INTERNATIONAL STANDARD ISO/IEC 23003-1:2007
TECHNICAL CORRIGENDUM 1

Information technology — MPEG audio technologies —

Part 1: MPEG Surround

TECHNICAL CORRIGENDUM 1

Figure 2 — Matrix compatible MPEG Surround

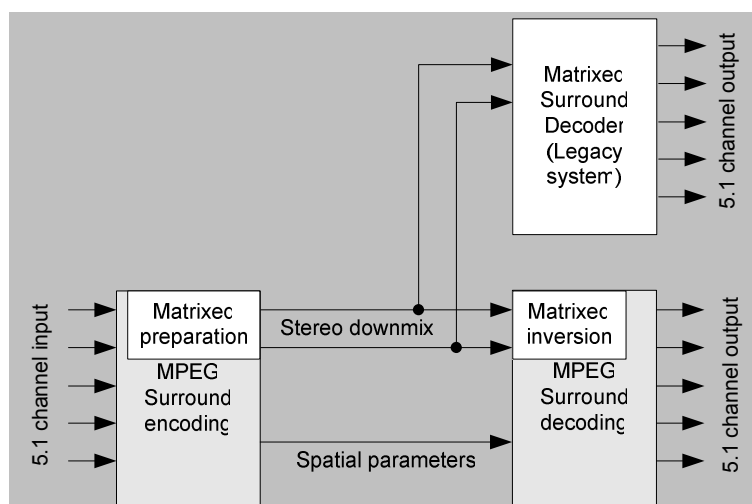
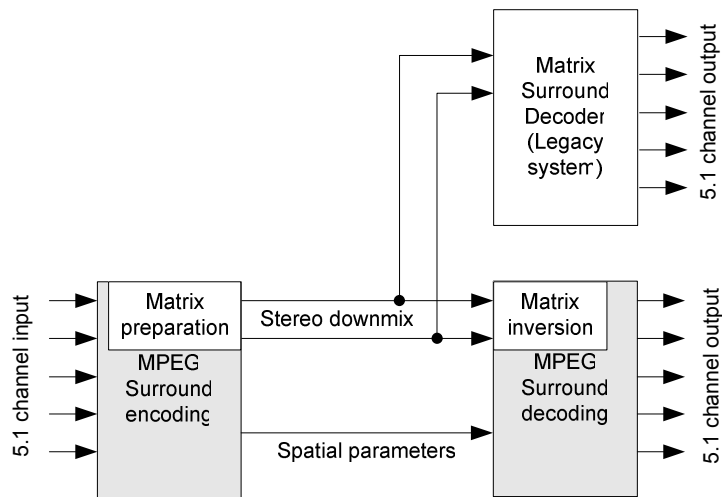
In subclause 4.3.1.6, replace:
